ADDENDUM NO. 1 ELEMENTARY ADDITION TO SUMTER CENTRAL HIGH SCHOOL

Architect Job No. 24-38 July 24, 2024 DCM # 20240619

PROJECT:	PROJECT NO.	REFERENCE:
ELEMENTARY ADDITION TO SUMTER CENTRAL HIGH SCHOOL	24-38	ADDENDUM NO. 1
ARCHITECTURAL ADDENDUM DRAWING	DATE:	SHEET NO.
ANCHITECTORAL ADDENDOW DRAWING	7/10/2024	ADD 1

SHEET TITLE: PARTIAL FLOOR PLAN -AREA B

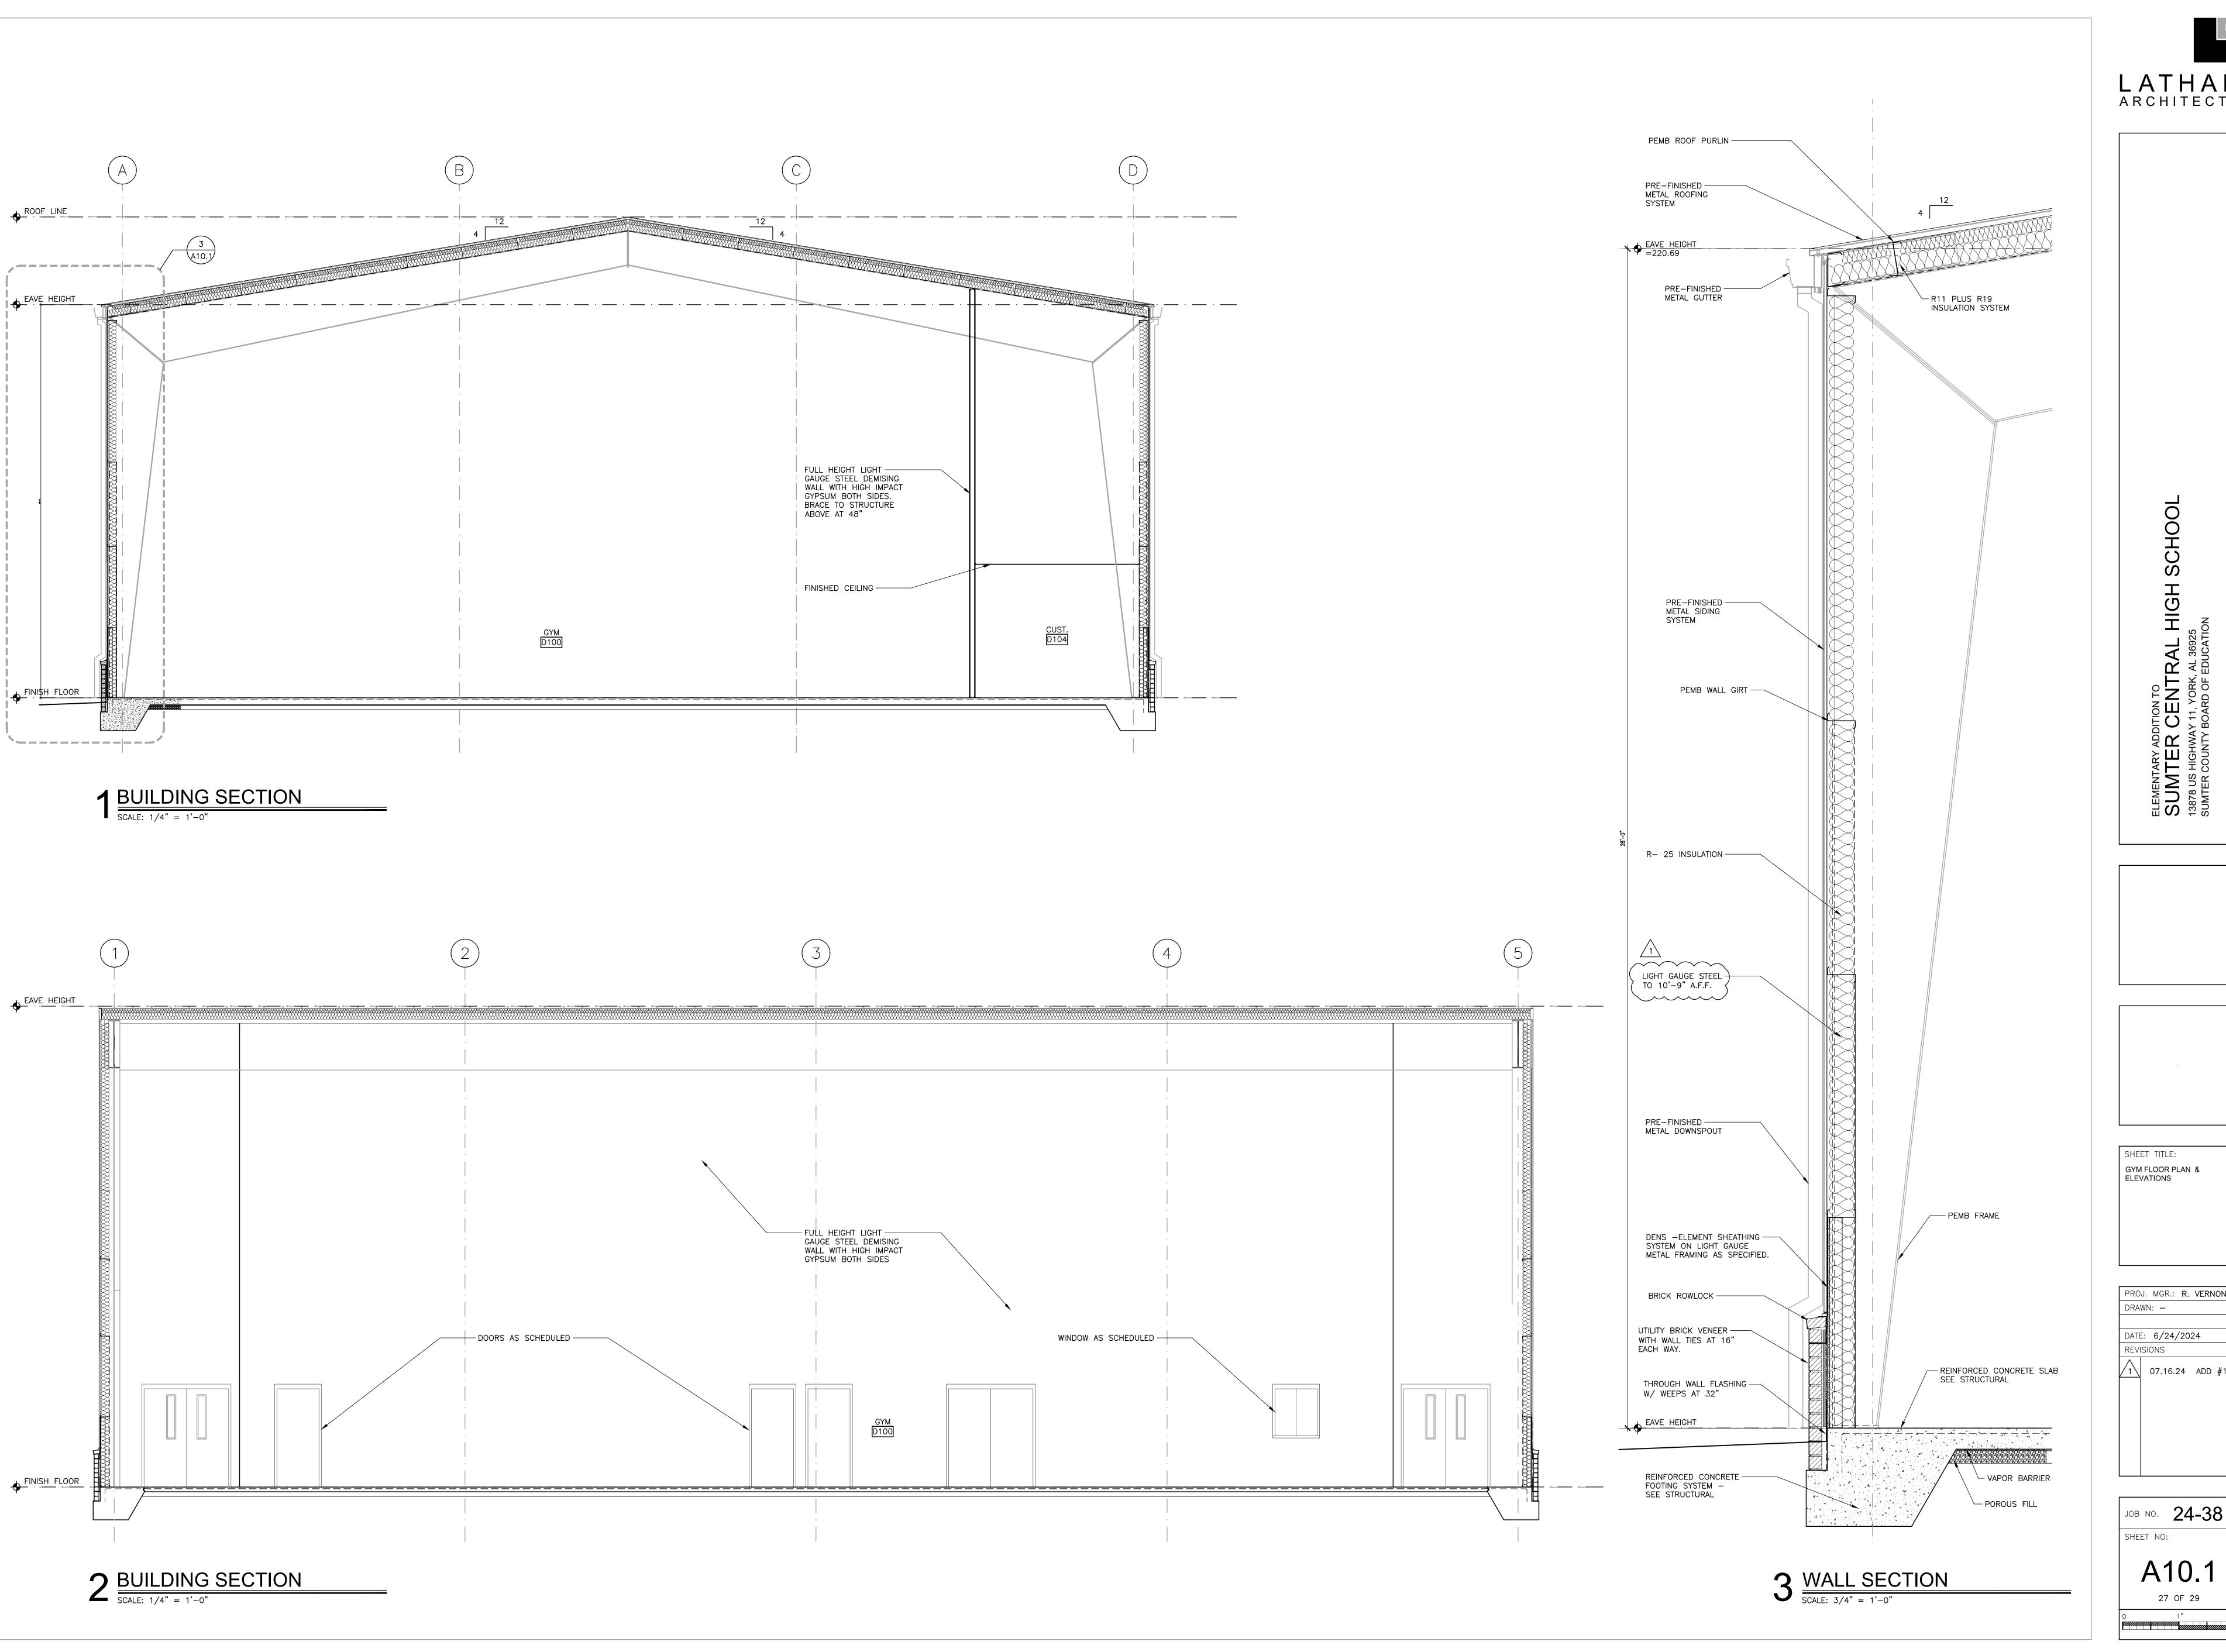
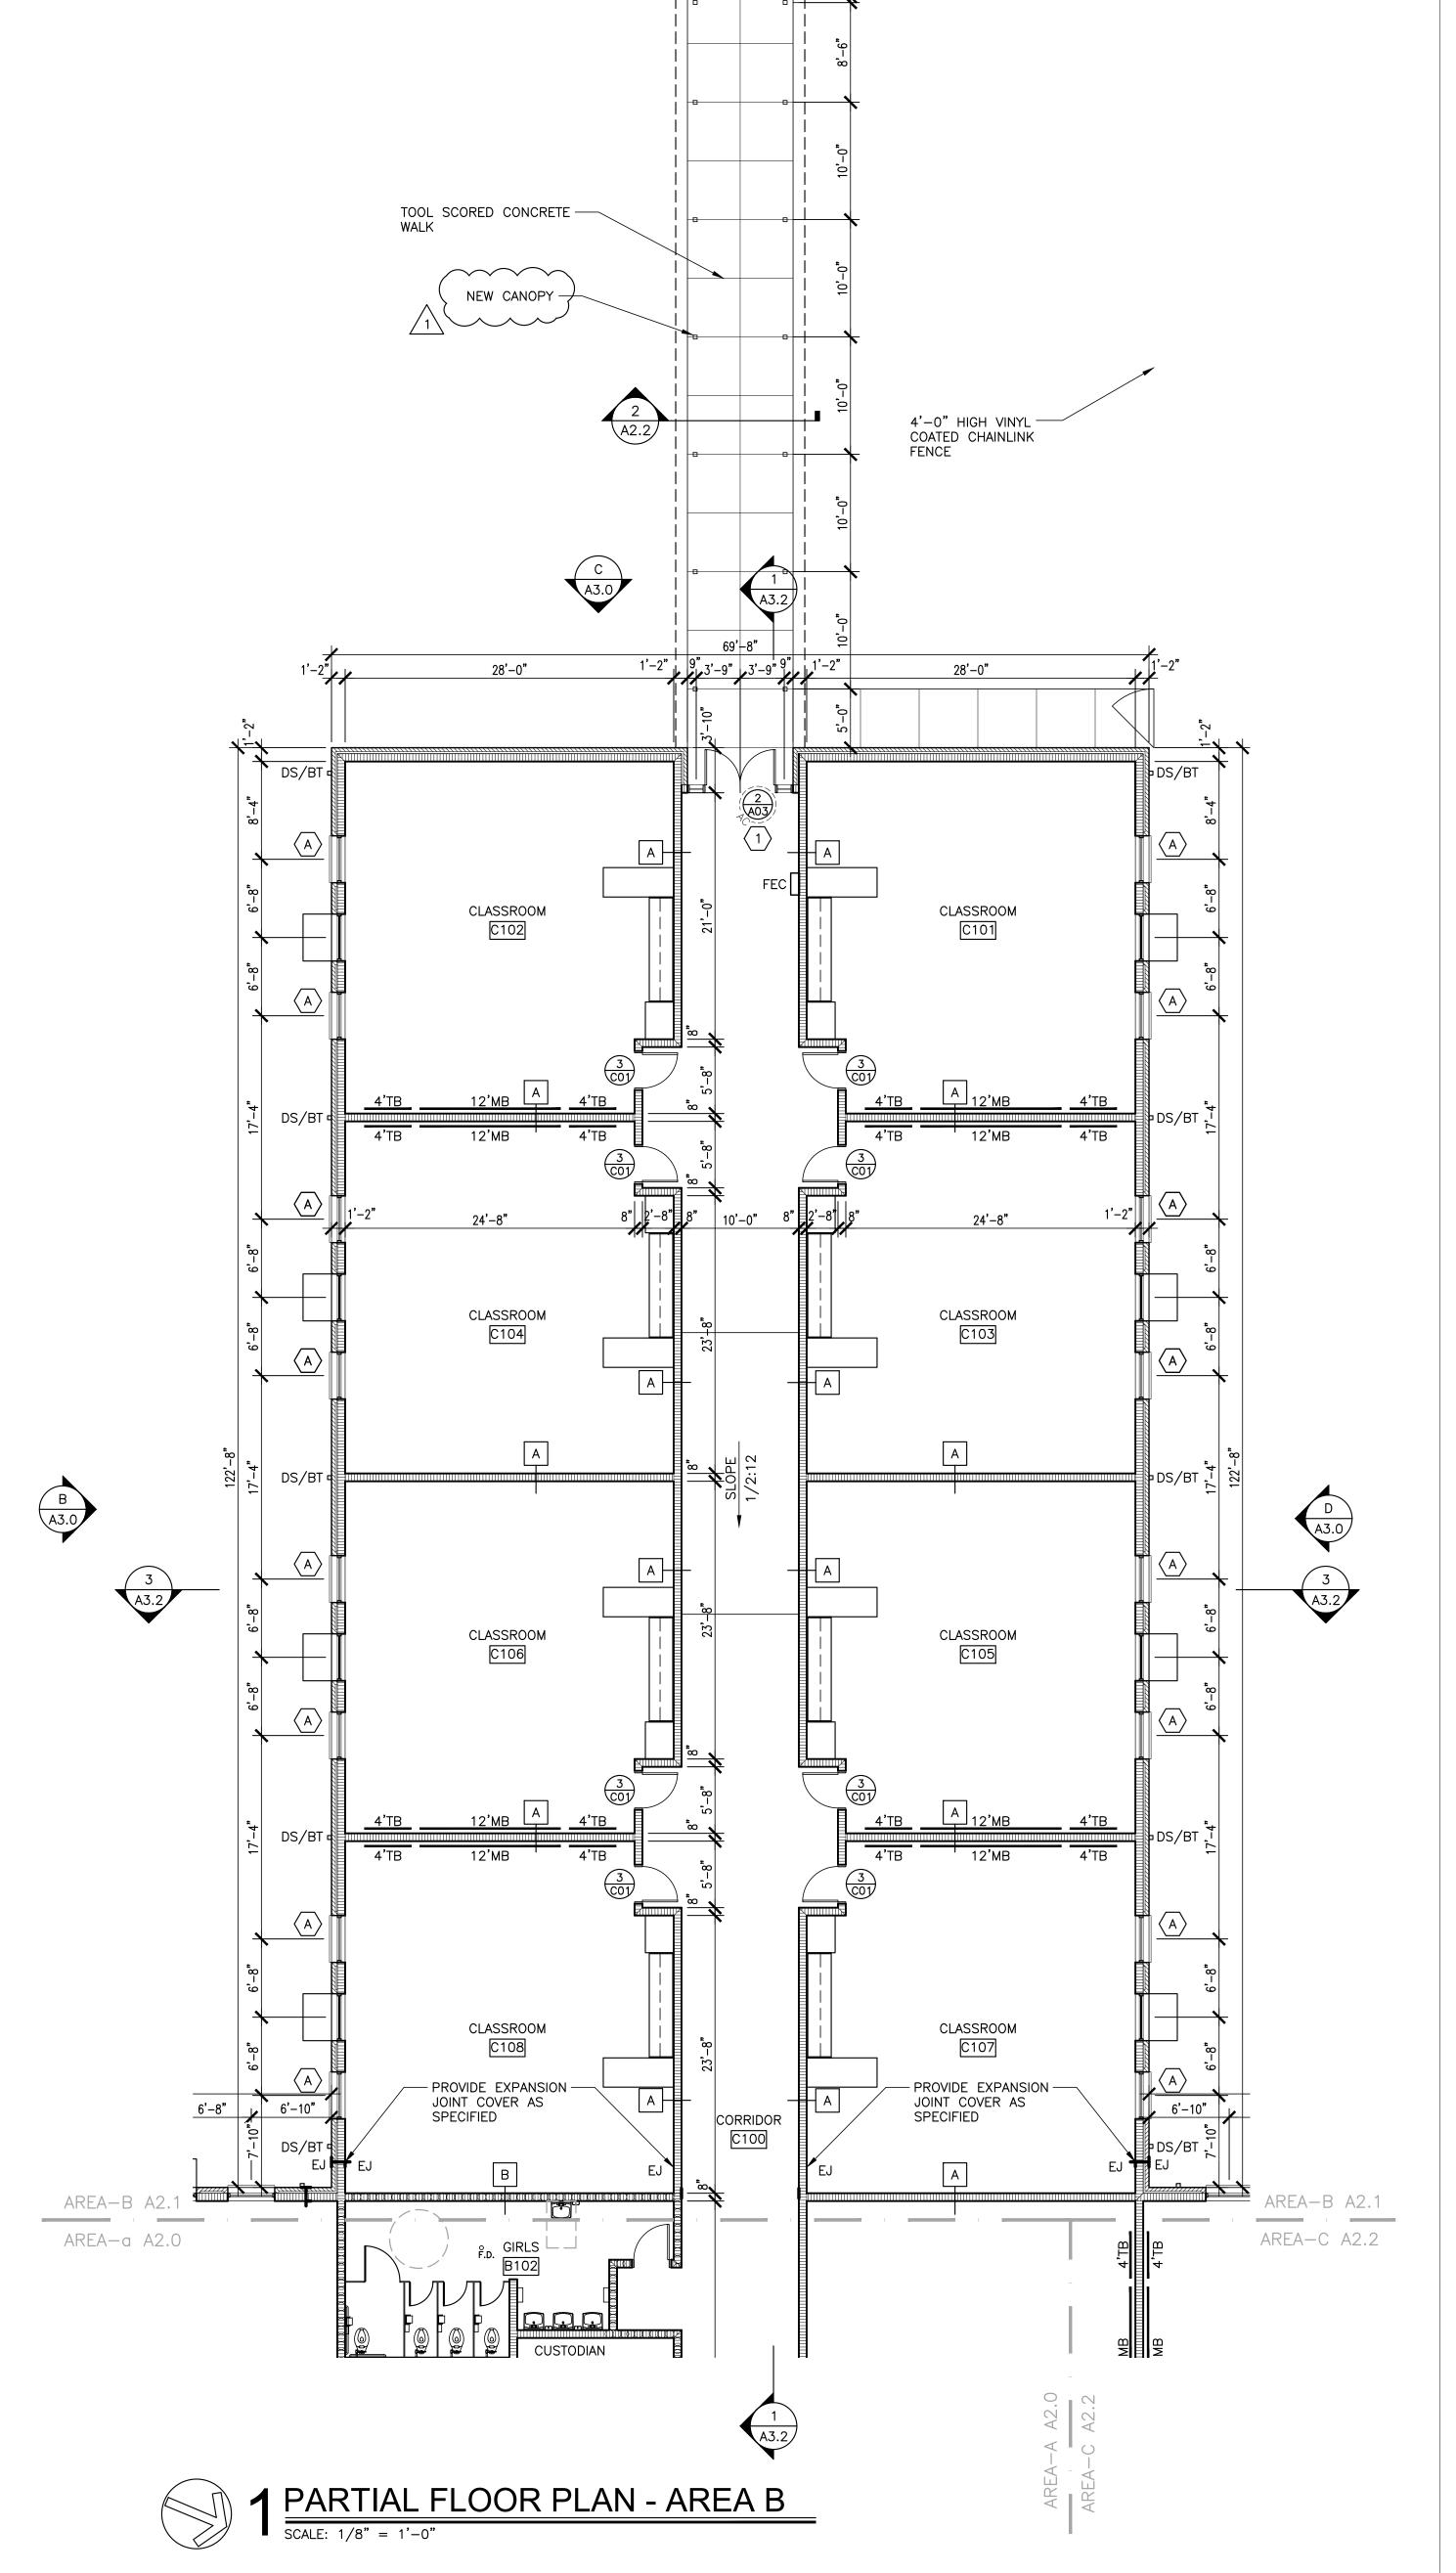
- 1. Add the attached architectural addendum drawing **ADD 1** in its entirety.
- See attached revised Sheet A2.2 to call out location for NEW CANOPY.
- See attached revised Sheet A10.1 added "LIGHT GAUGE STEEL TO 10'-9" A.F.F".
- 4. See attached **A10.3** for revisions to the Reflected Ceiling Plan.
- 5. See Sheet <u>S3.1</u> Sections and Details: Steel veneer lintel with anchorage revised to have plate extension to better coordinate with architectural drawings as well as "Contractor Option" added.
